Subject: Airport Plaza Shopping Center
 Workplan review
 CRWQCB File No. 01-0413 (ES)

Subject: 239 Hesperian Boulevard, Hayward
Remedial Action Workplan
Revision 3, Dated September 8, 1995

Subject: 23958 Hesperian Boulevard, Hayward, CA
Remedial Action Workplan
100% Submittal

**100% SUBMITTAL
REMEDIAL ACTION WORKPLAN
FOR
THE INVESTIGATION AND REMEDIATION OF
VOLATILE ORGANIC COMPOUNDS (VOC'S)
FOUND IN GROUNDWATER
AT
AIRPORT PLAZA SHOPPING CENTER
N/W CORNER OF HESPERIAN AND W. WINTON
23958 HESPERIAN BOULEVARD
HAYWARD, CALIFORNIA
CRWQCB FILE 01-0413 (ES)**

2" MONITORING WELL CONSTRUCTION DETAIL

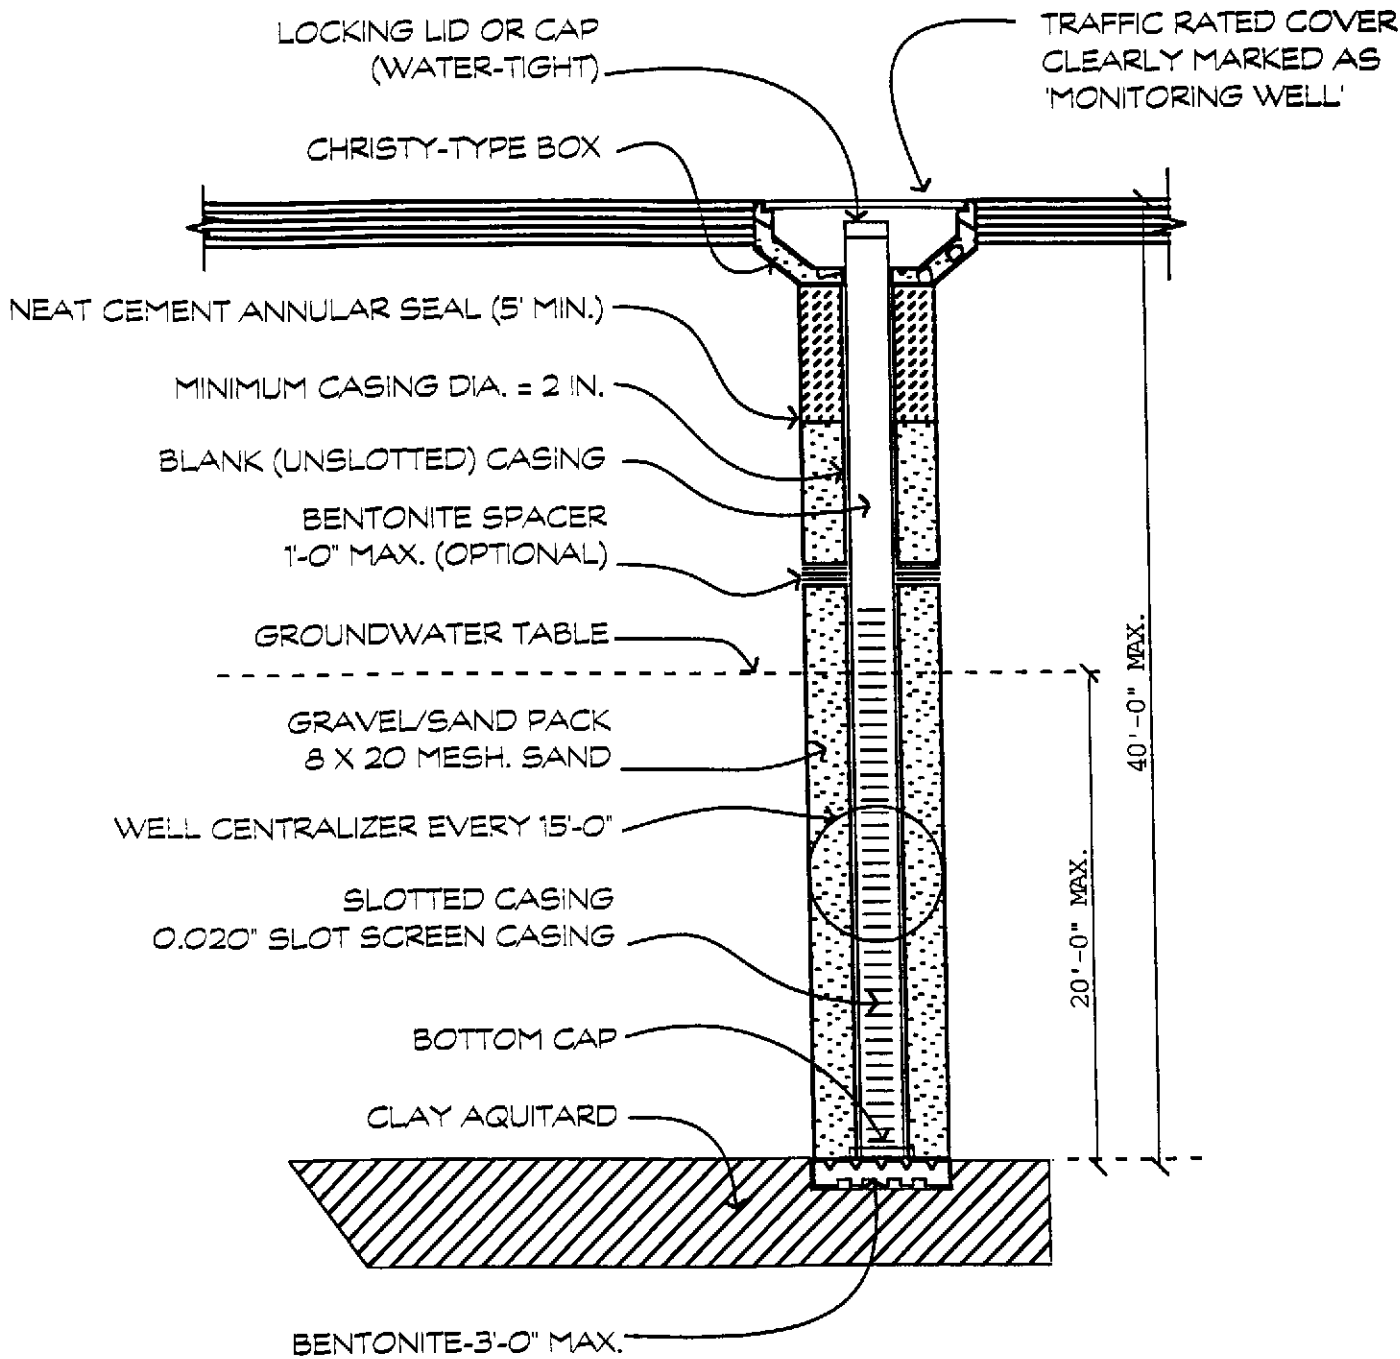
Reference: Section 7, drawing 7.11, Monitoring Well Construction Detail,

We have changed the 2" monitoring well detail to reflect the correct bentonite spacer location directly below the neat cement annular seal.

1 SITE PLAN - PROPOSED MONITORING WELLS, SOIL BORINGS AND GROUND WATER SAMPLES
1" = 40'-0"

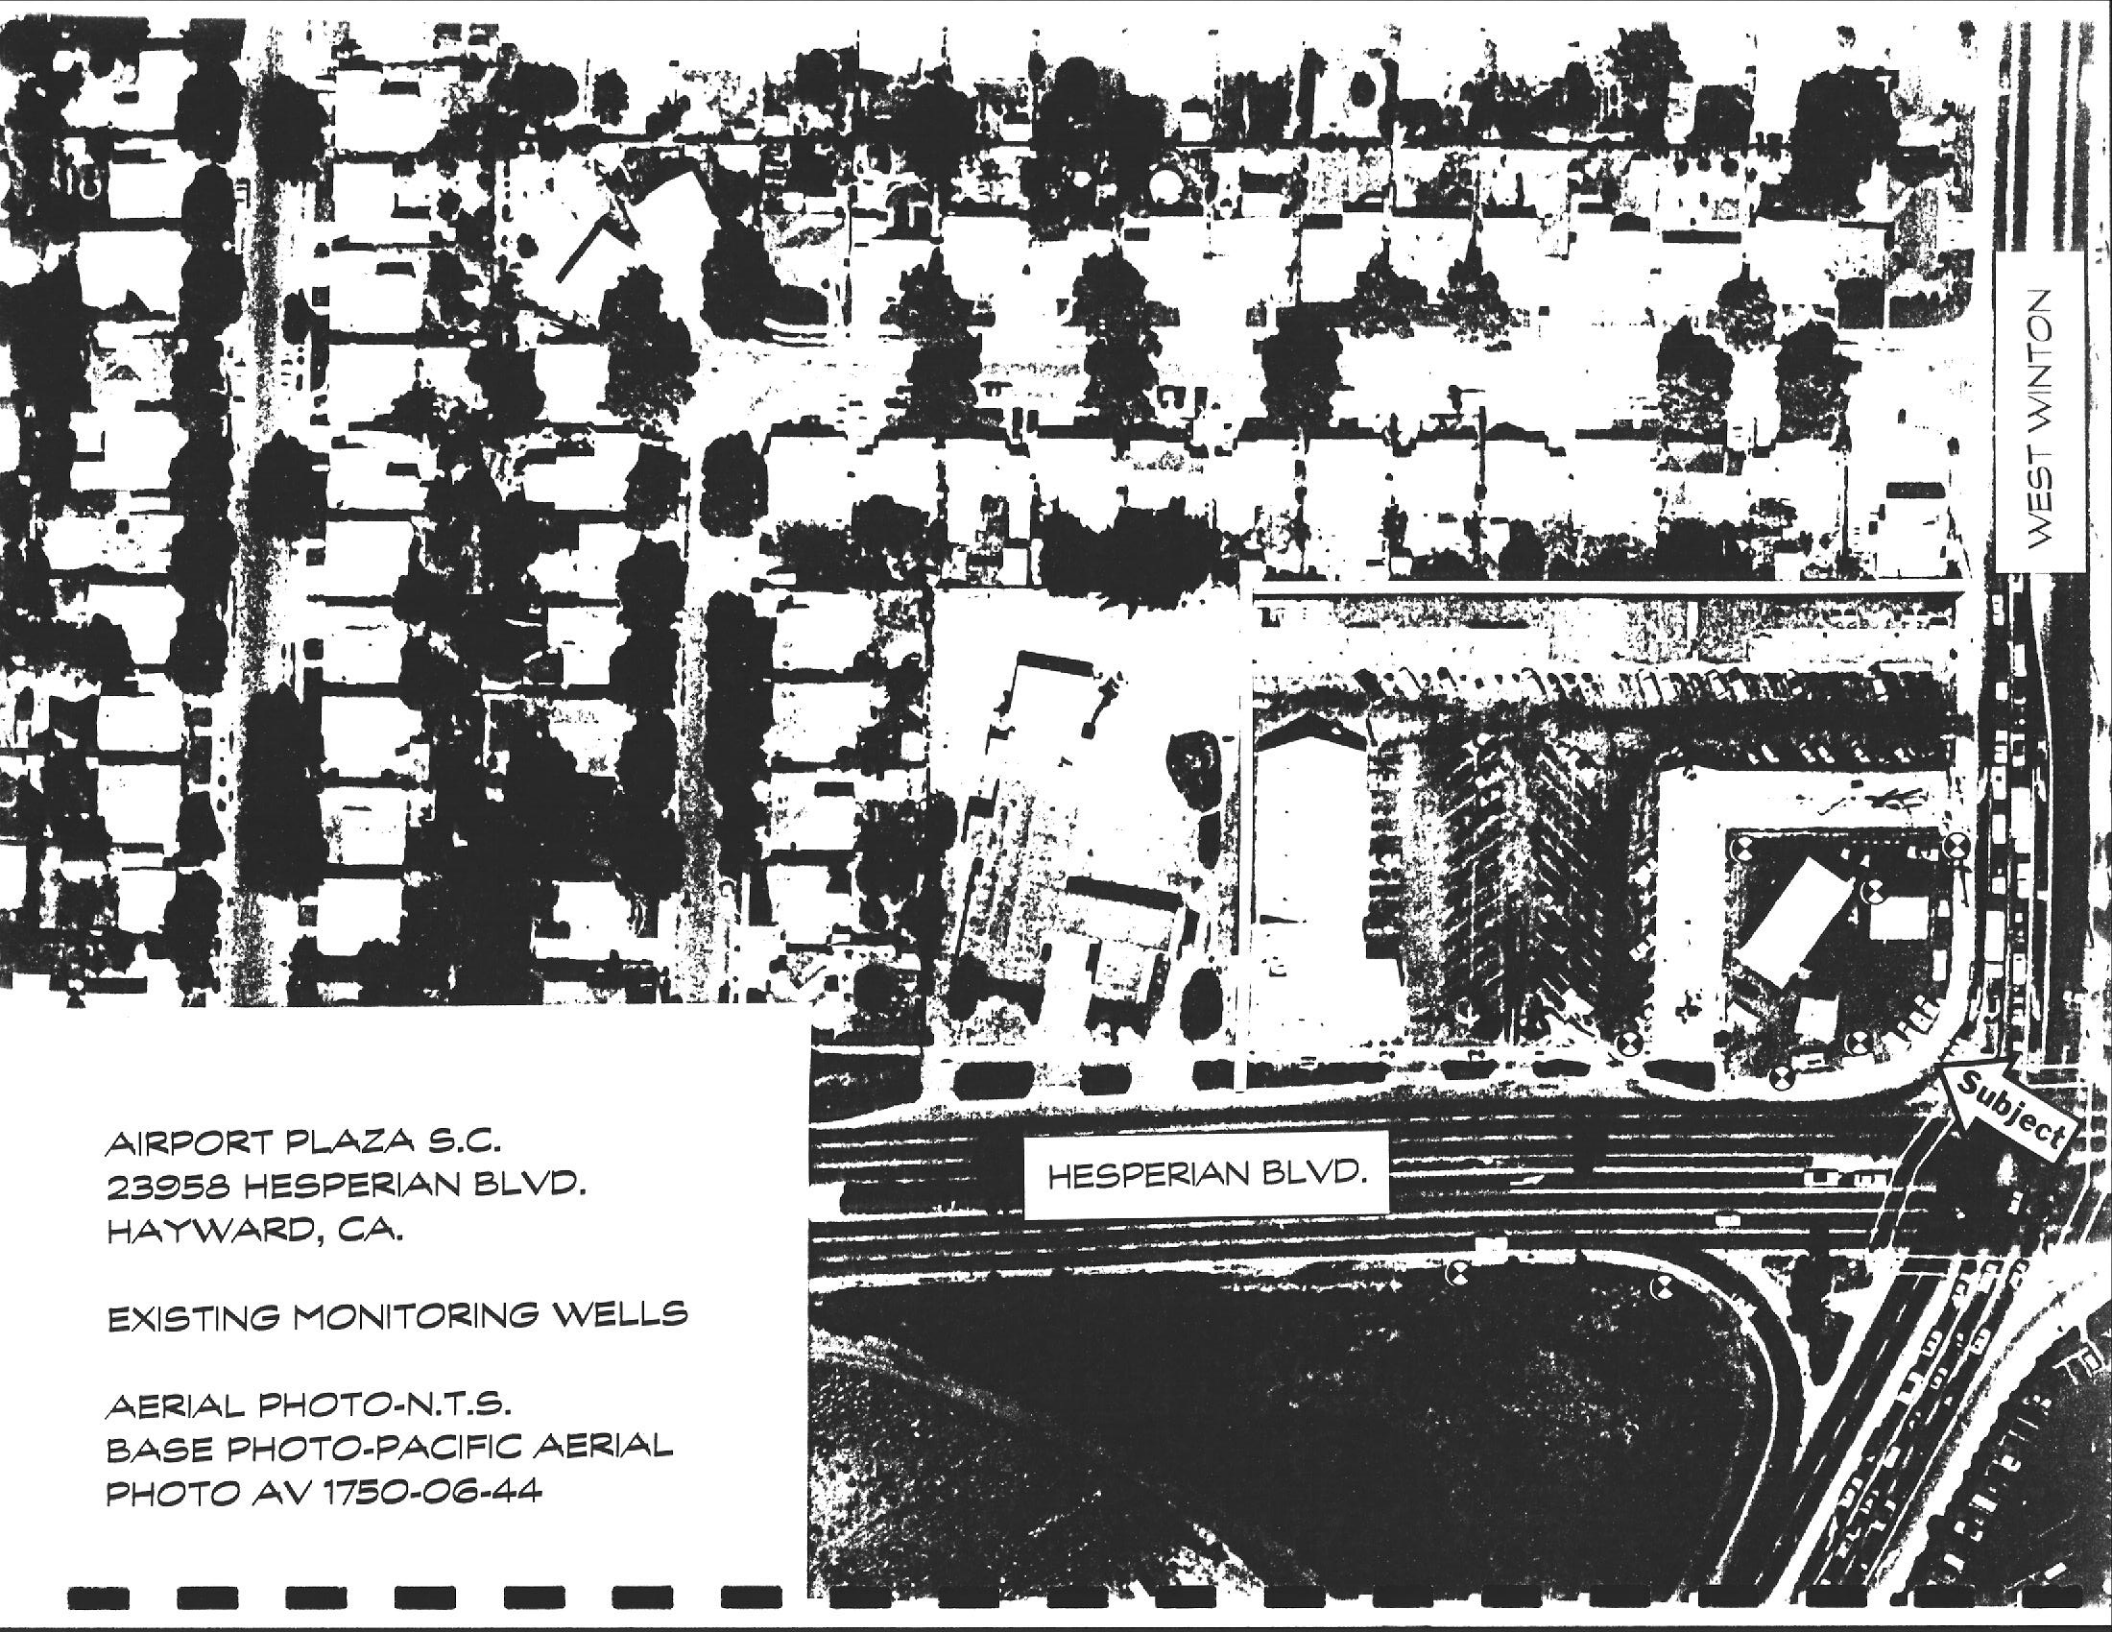
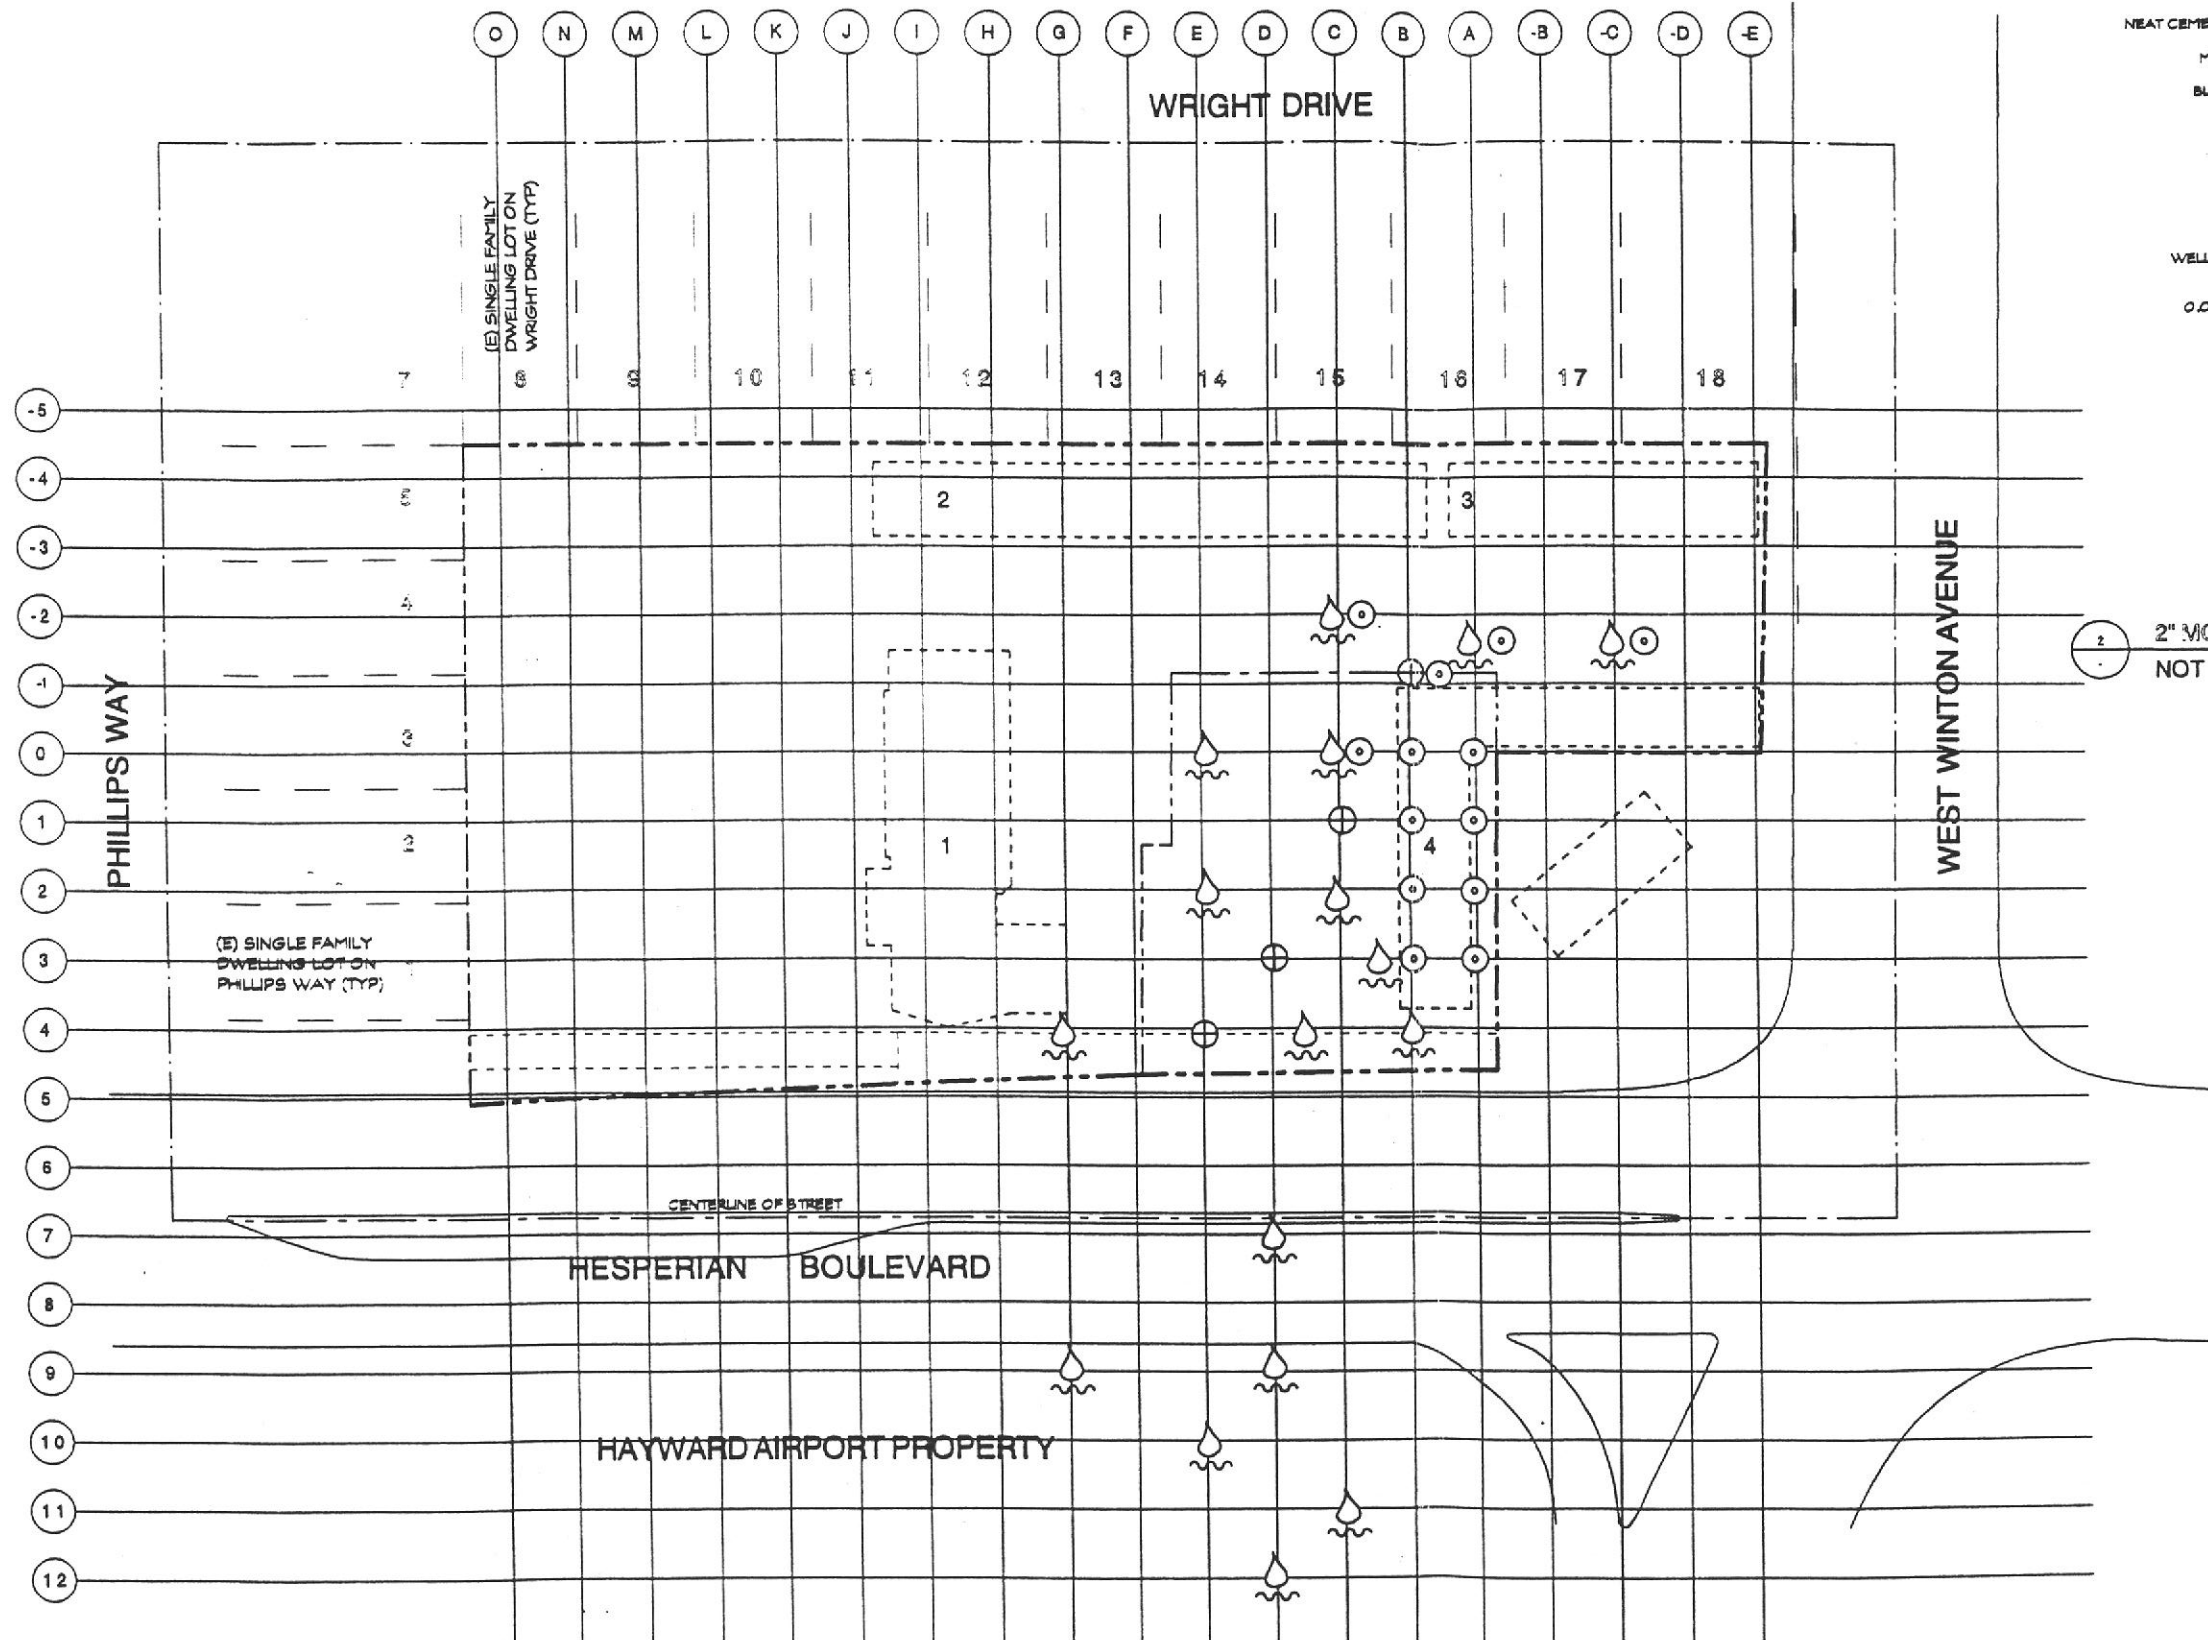
Reference: Section 11, Sheets A1 through A3 drawings

The new drawings reflect the two added borings at the planter and new legend symbols.
